# Wisconsin Department of Transportation

**Proposal #14: 2967-17-71, WISC 2024226**  
**C Milwaukee N 76<sup>th</sup> St**  
**Bridge over UPC RR B-40-380/1**  
**STH 181**  
**Milwaukee County**

This is Addendum No. 02, which provides for the following:

**ADDENDUM NO. 02**

Addendum No. 02  
ID 2967-17-71  
Revised Sheet 212  
February 6, 2024

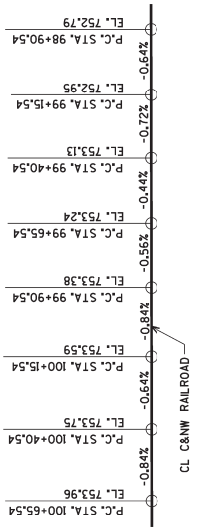
<b>Revised Plan Sheets</b>	
Plan Sheet	Plan Sheet Title (brief description of changes to sheet)
212	Revised bid item quantity table on sheet.
240	Revised bid item quantity table on sheet.

STEEL PLATES AT NORTH ABUTMENT TO BE SAND BLASTED AND PAINTED. BEARING AT NORTH ABUTMENT ORDER 5 TO BE REMOVED. BENT ANCHOR ROD REPLACED AND BEARING RE-INSTALLED. BEARING BENT ANCHOR ROD TO BE RE-SET. PAID FOR UNDER THE BID ITEM "BEARING MAINTENANCE".

EXISTING BEARINGS TO BE CLEANED AND PAINTED AT SOUTH ABUTMENT AND PIERS.
